Department of Planning and Zoning

MEMORANDUM

To: Development Review Board
From: Mary O'Neil, AICP, Principal Planner
Date: December 6, 2016
RE: ZP 16-1400LL

Request: Appeal of a lot line adjustment between 80 Colchester Avenue, 27 Fletcher Place and 49 Fletcher Place. (Zoning permit appealed was specifically for 80 Colchester Avenue parcel.)

Approved Site Plan

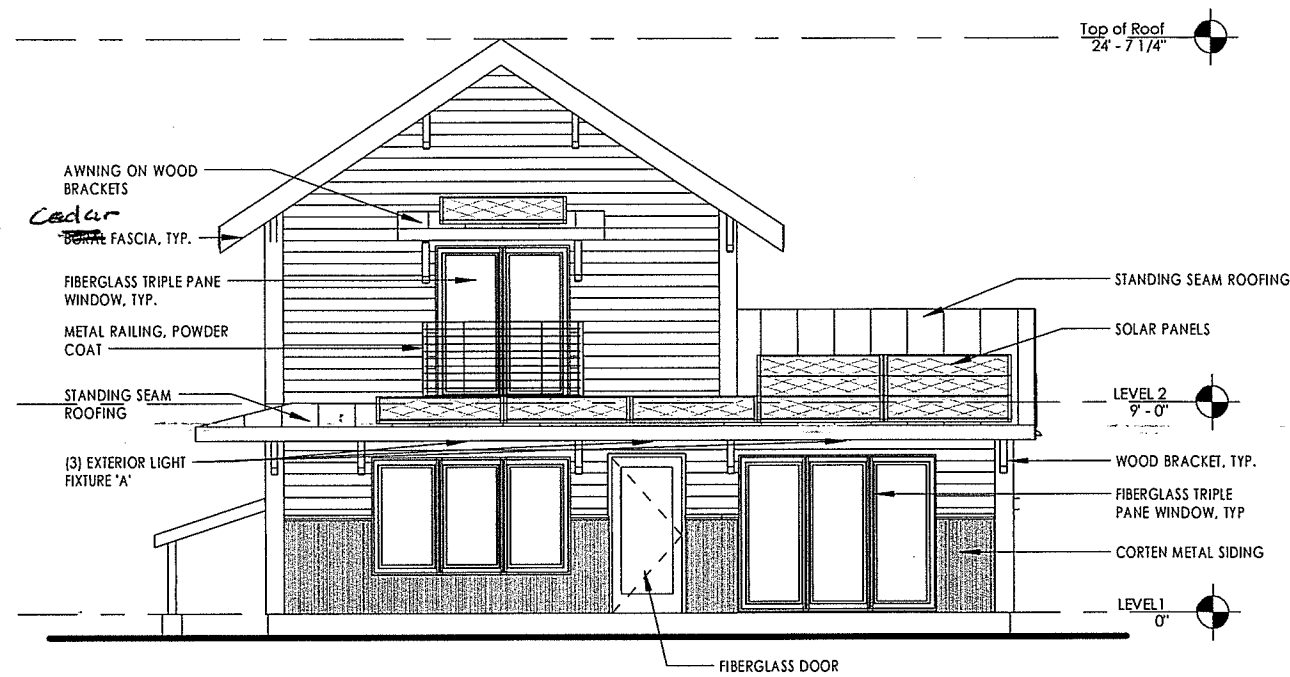
The Findings, below, reflect review of the revised site plan with the north boundary interpreted as a *side yard*. The applicant requests interpretation of the north boundary as a *front yard*, which would affect setbacks.

The existing westerly home on the 6-8 Proctor Place parcel establishes the front yard setback for Proctor Place. No change is proposed there. The easement area north of this parcel is not a Front yard as it does not front on a public right of way, is privately owned, and is not public.

Approved elevations

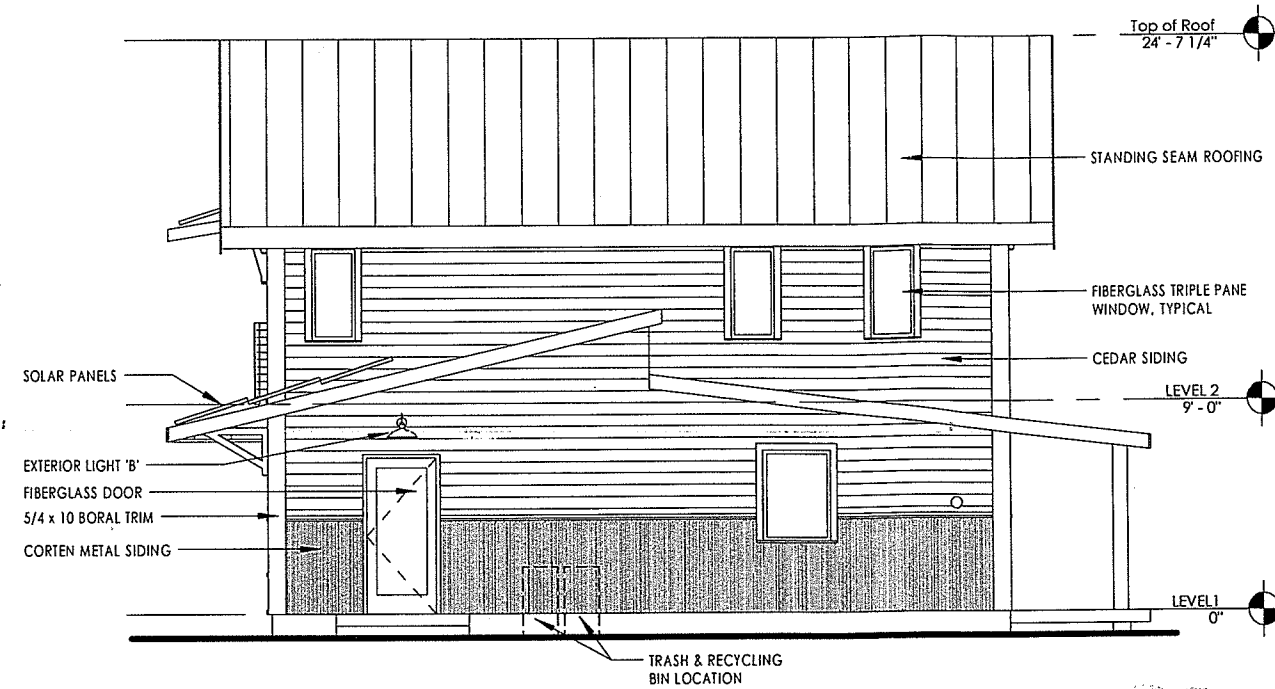
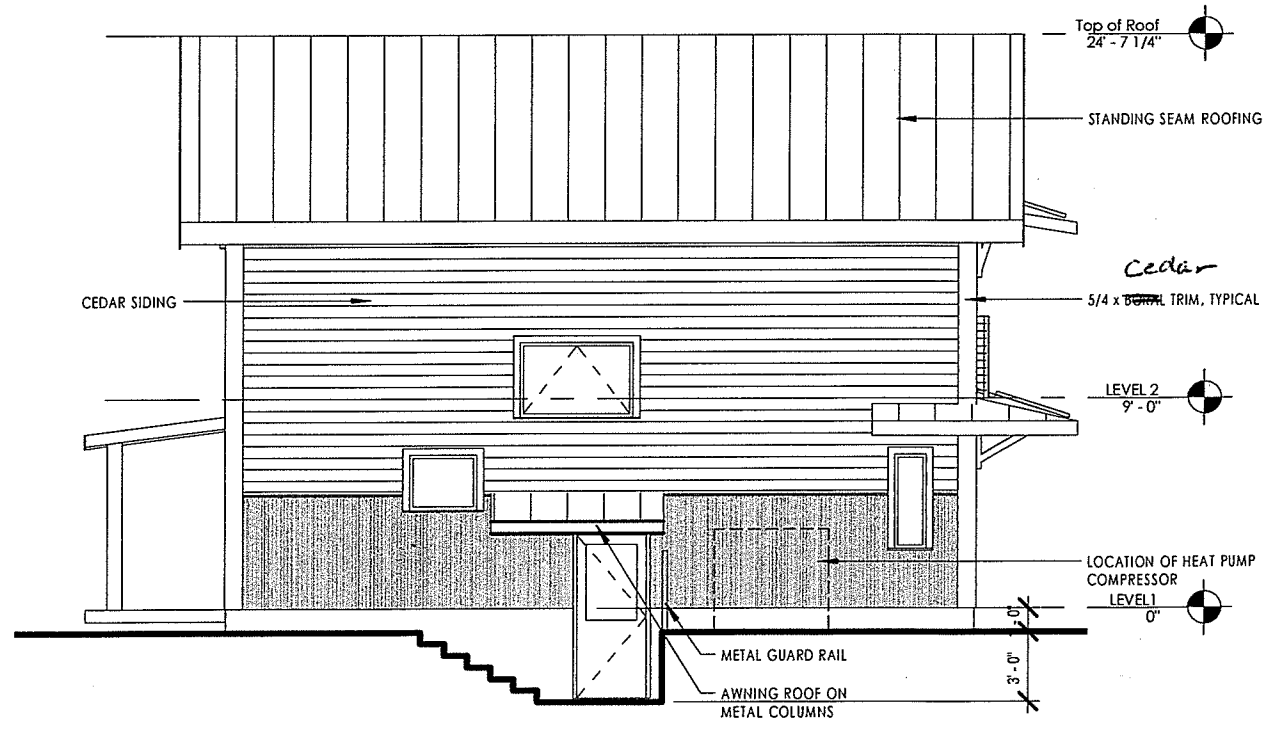
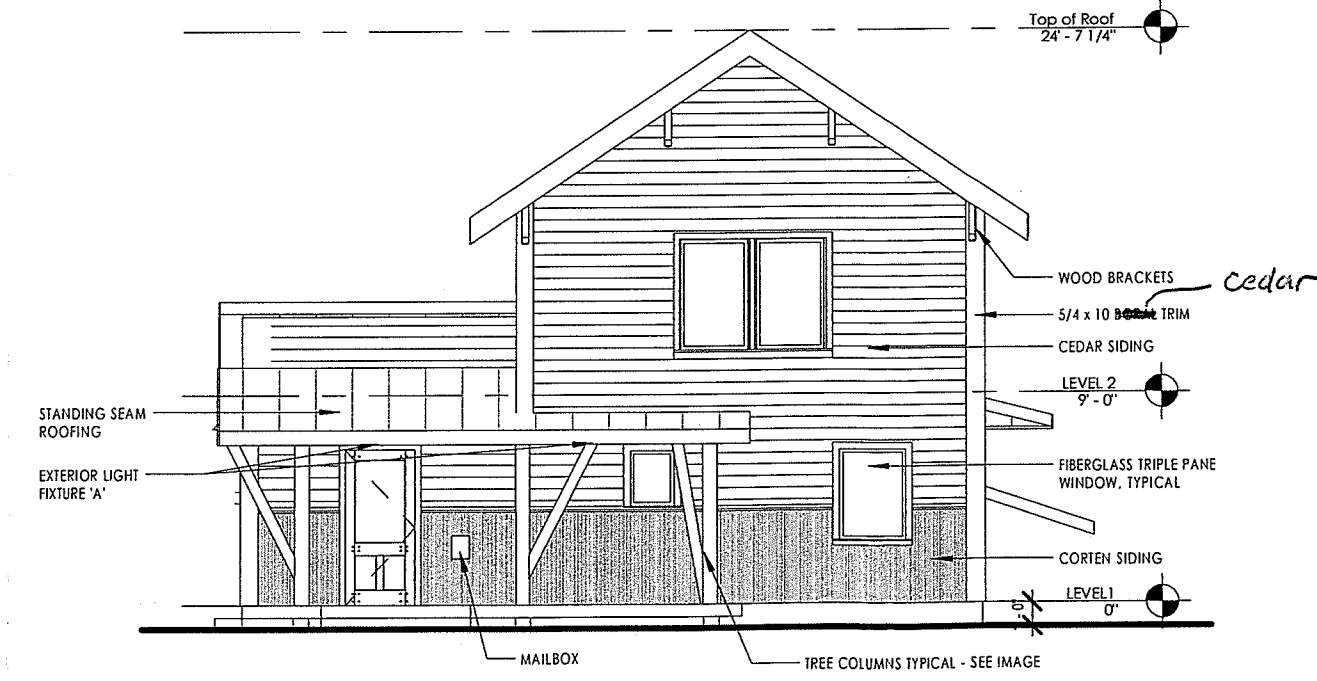
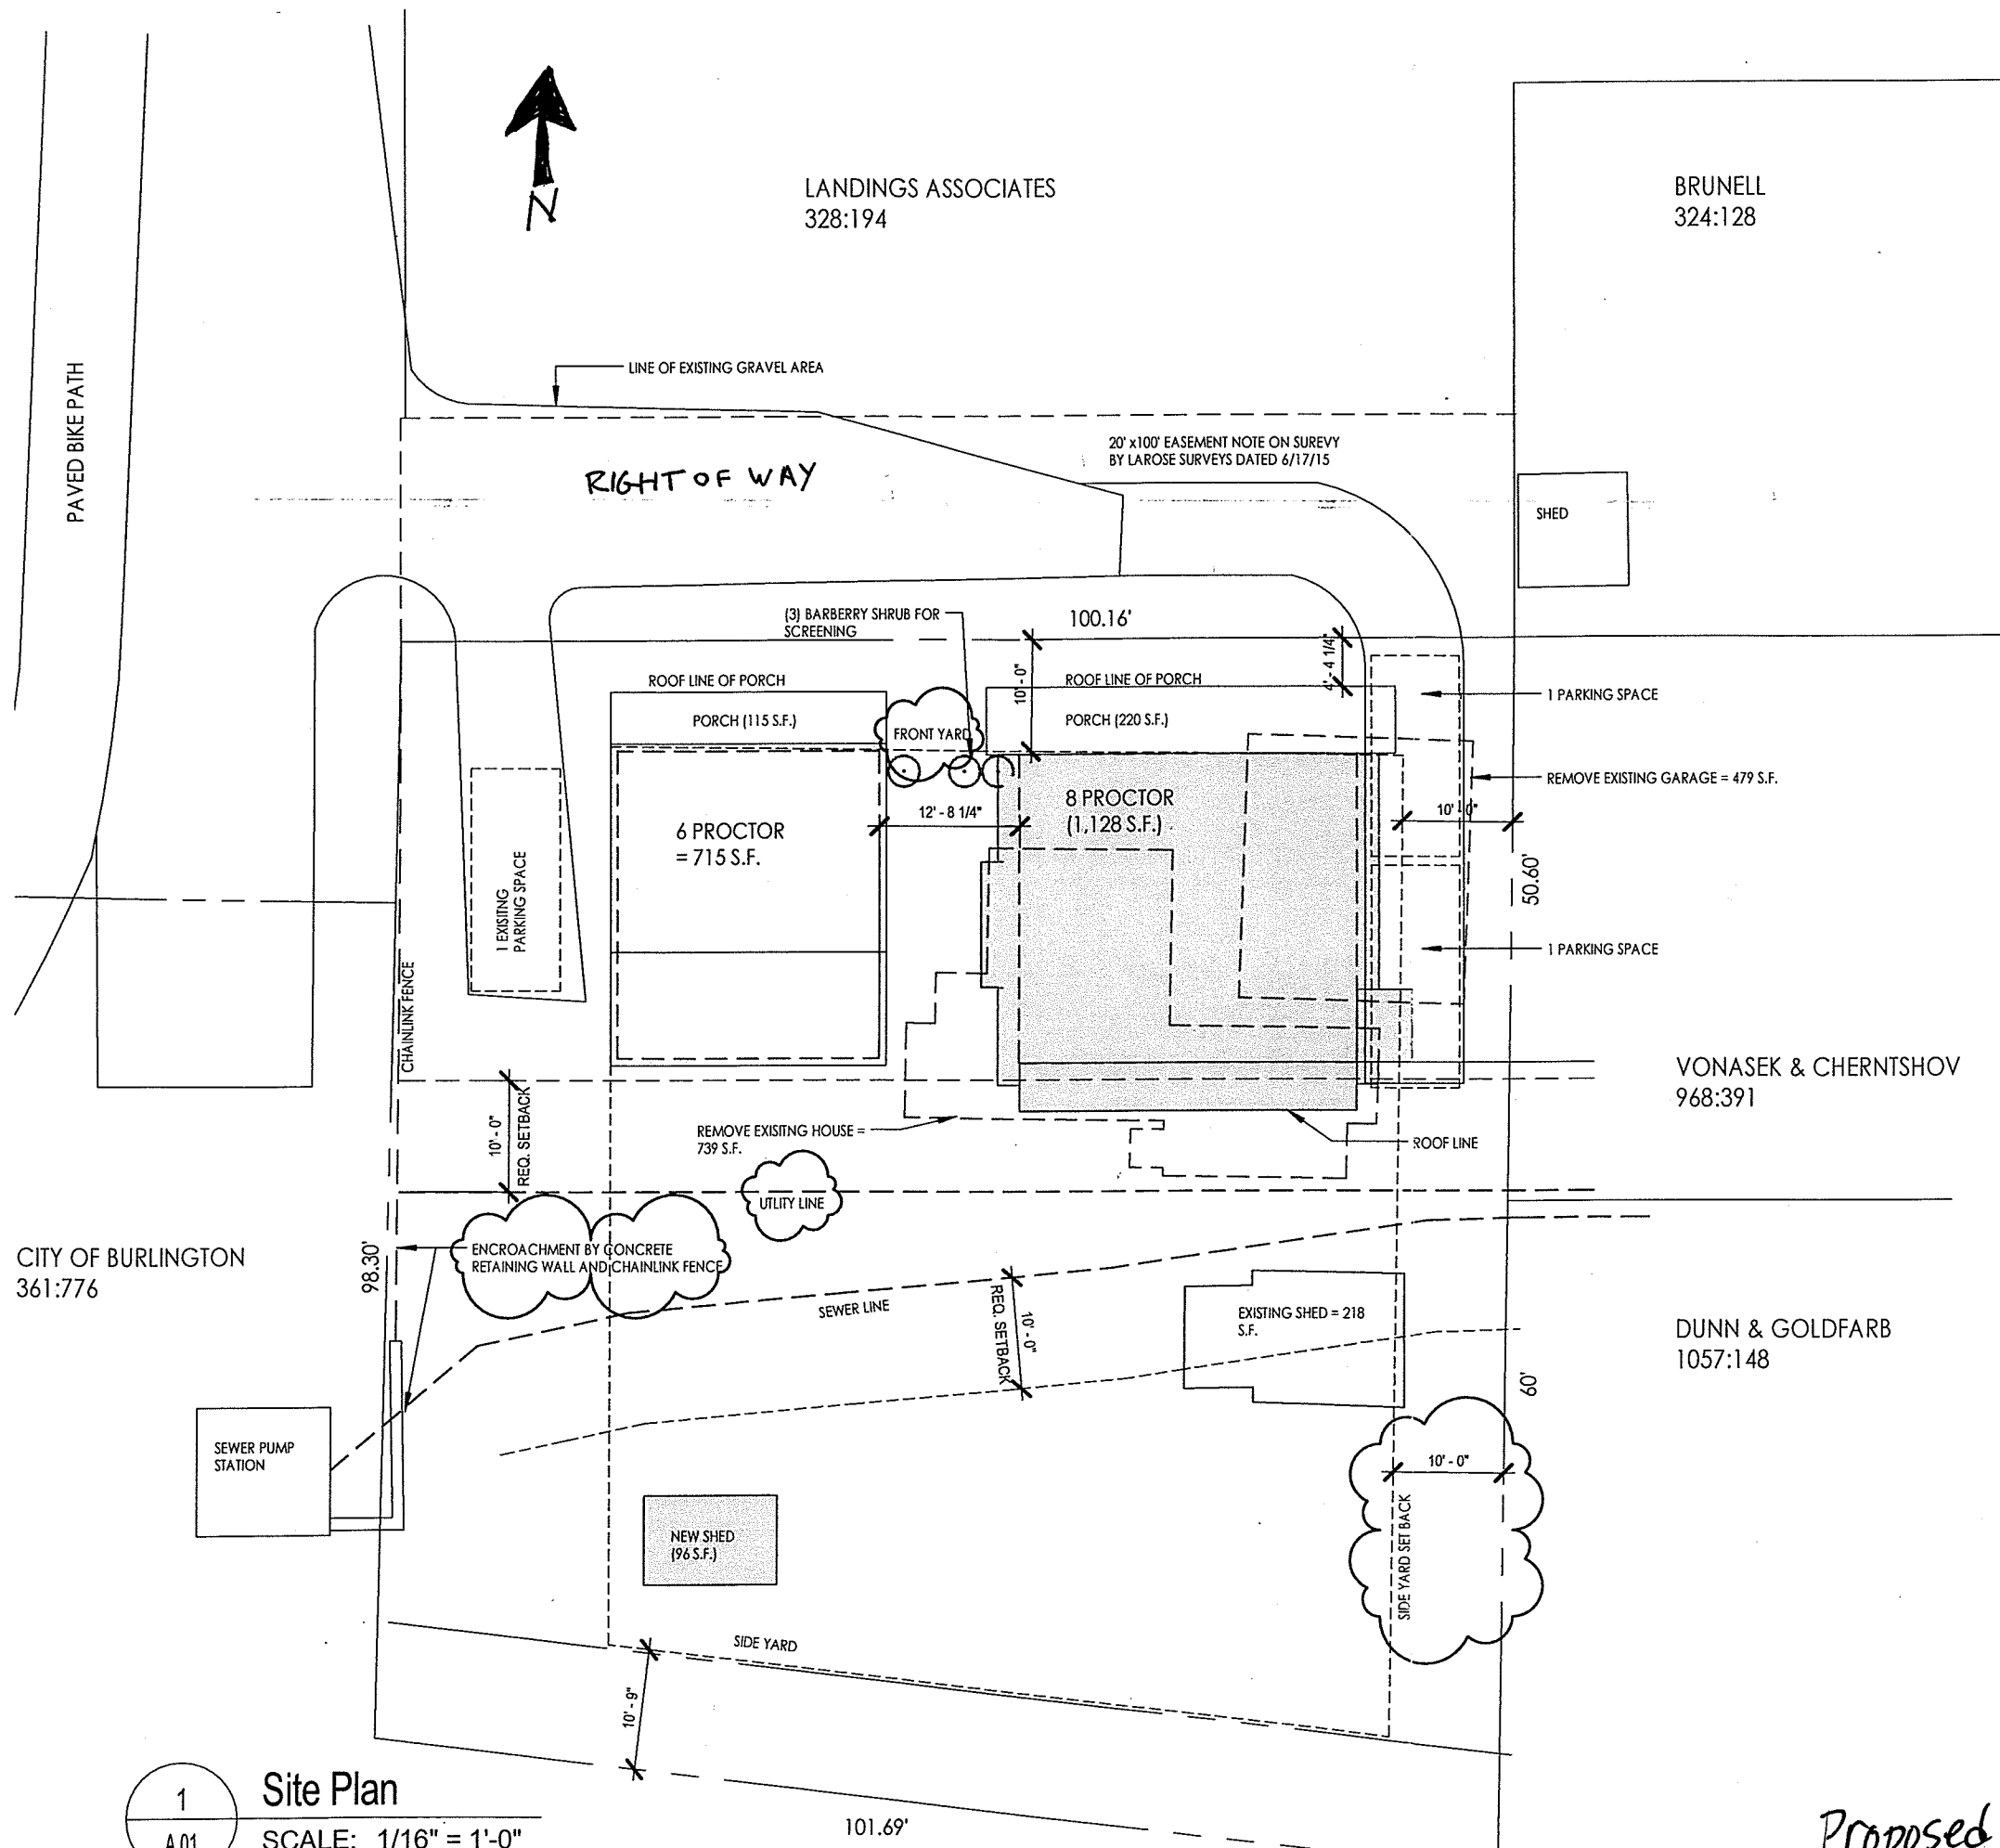
At present the mobile home as a low profile; single story with several building additions. The applicant has provided a revised home design with a gable front orientation toward Proctor Avenue and eaves-front to the north and south. It is not dissimilar from the scale of the companion house to the west on the same lot, however encroaches into the easterly (rear) setback by virtue of the 2nd story. See Non-conformities, Section 5.3.5 (a), above. **Adverse finding.**

The broadest expanse of glazing is located on the south elevation which will provide the most benefit of passive solar gain. Windows are distributed around the structure, aligned more vertically than horizontally on the north and east as required by this standard. Greater consideration to the “balance” and arrangement of door and window openings across the building’s façade would calm the overall design.

SHEET NO.
C-3

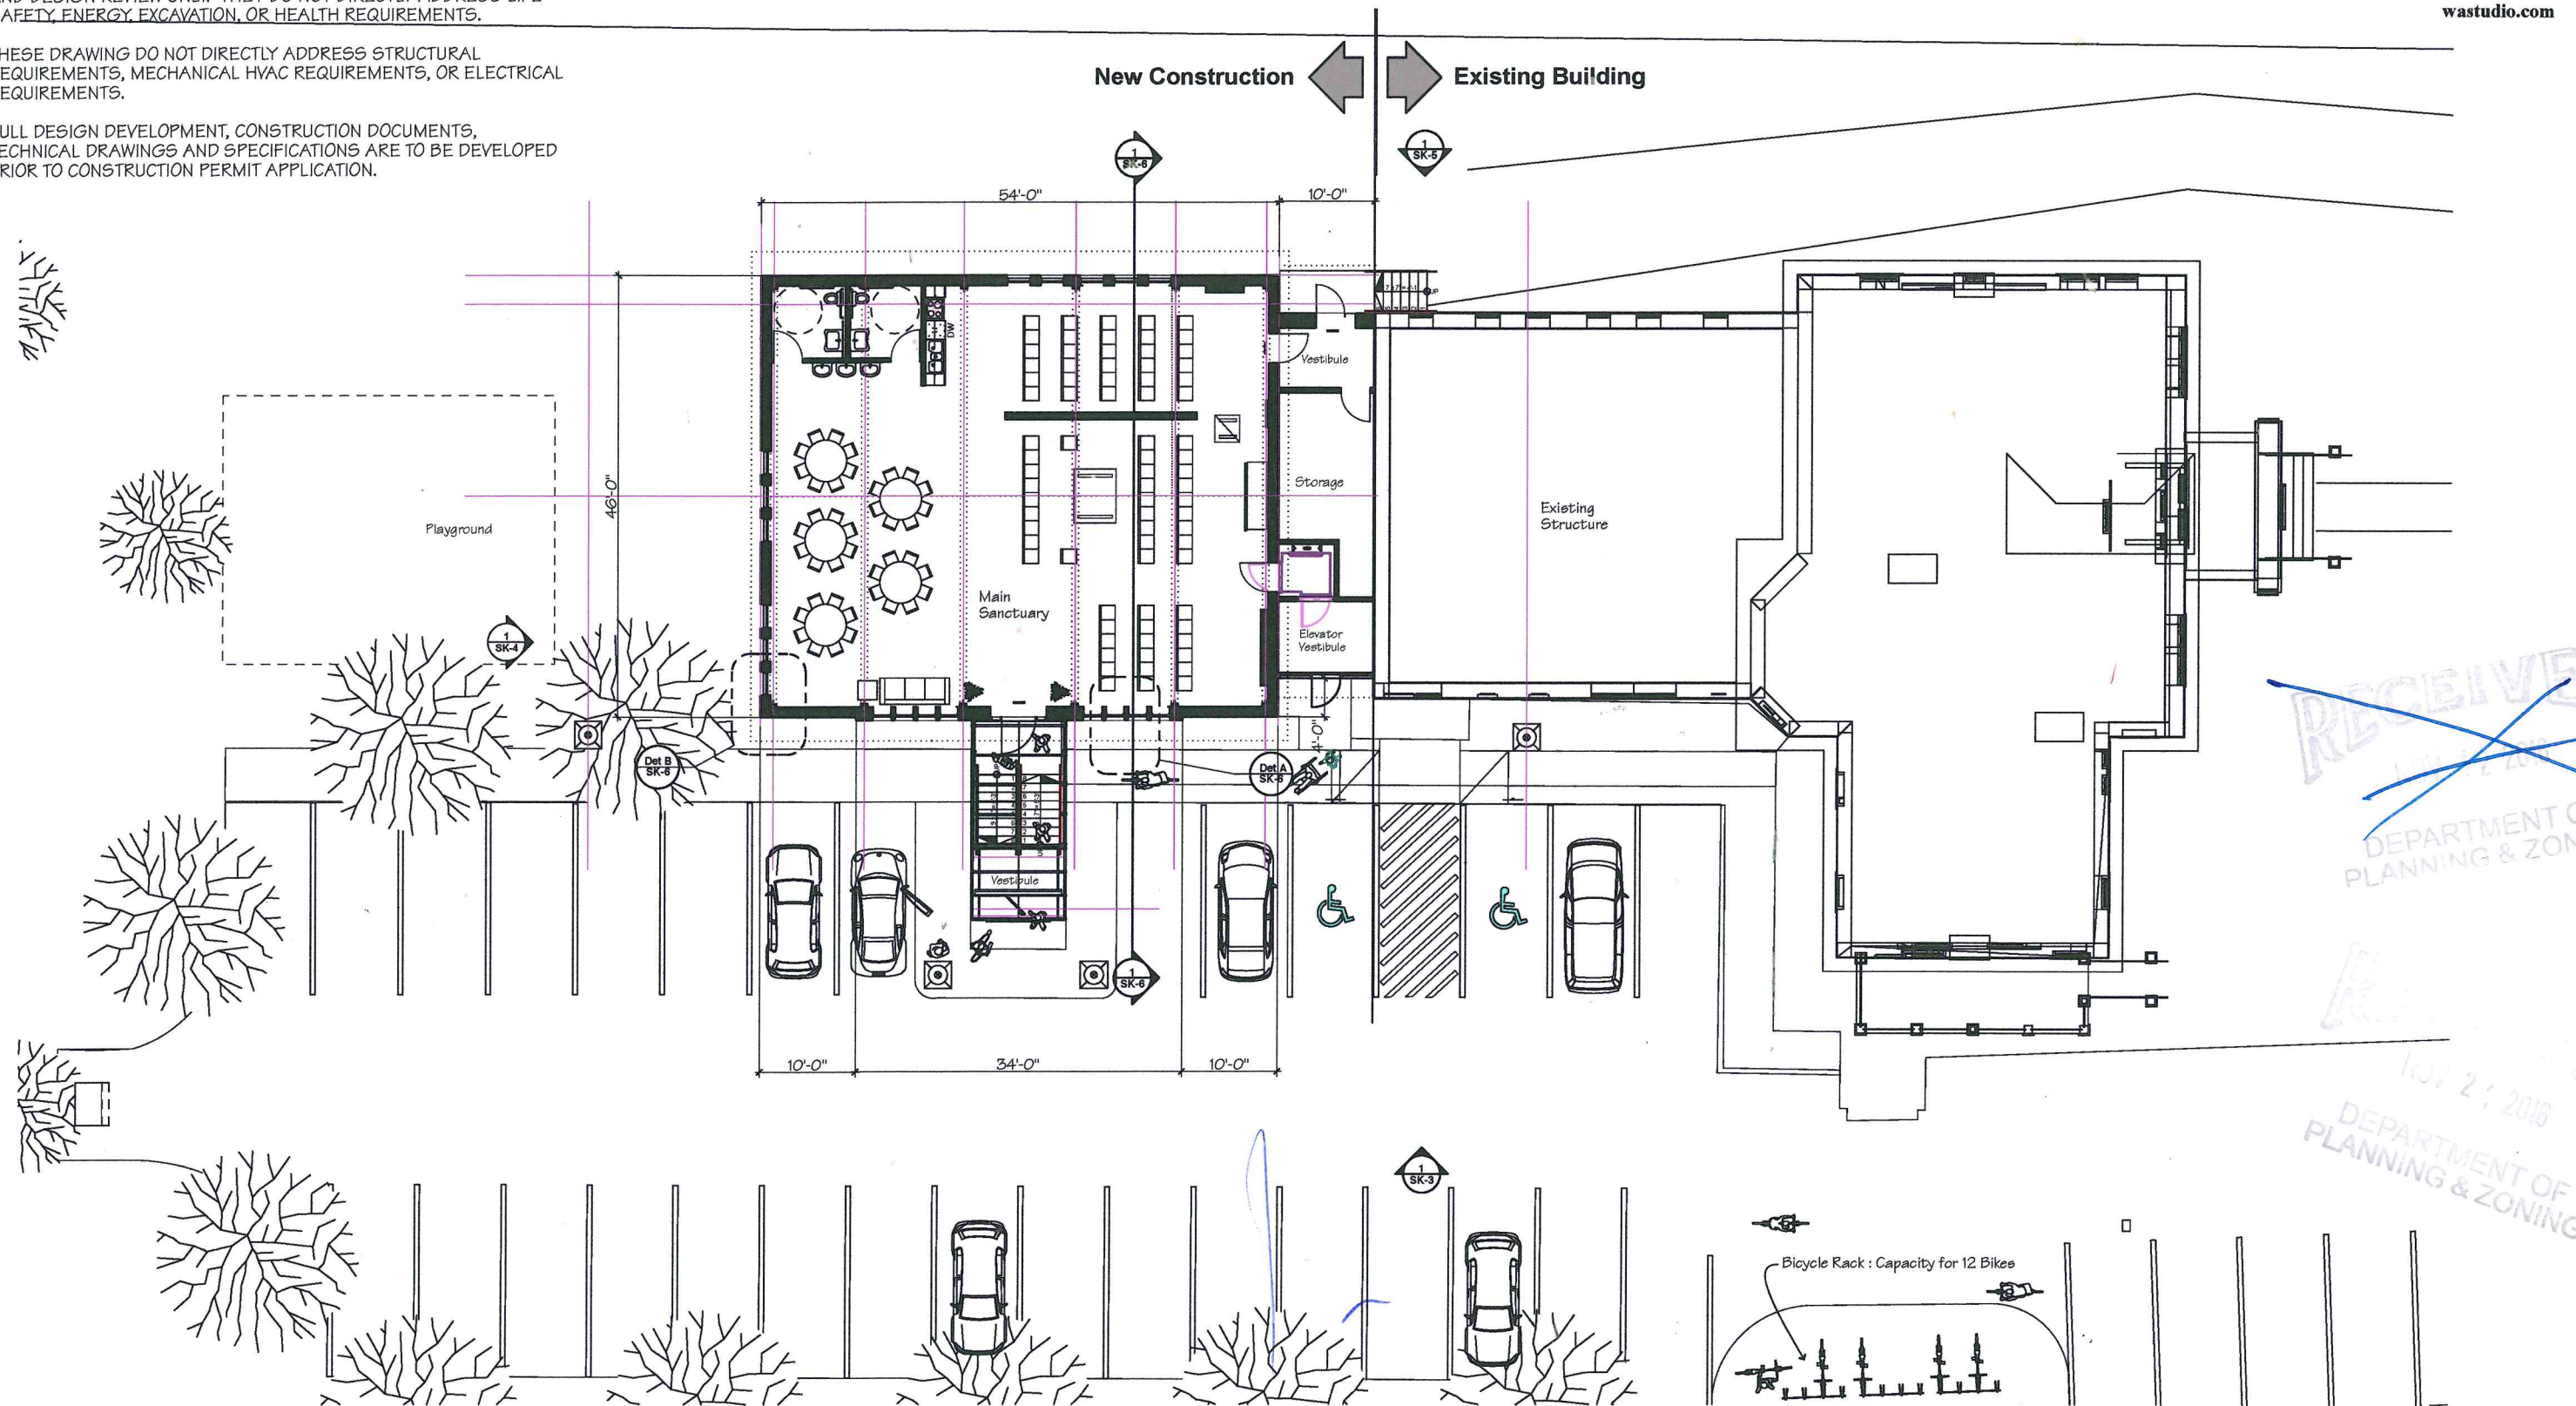
An erosion prevention and sedimentation control plan has been submitted (sheet C-3), and identifies erosion control matting in areas of soil disturbance on steeper sections of the property. **(Affirmative finding)**
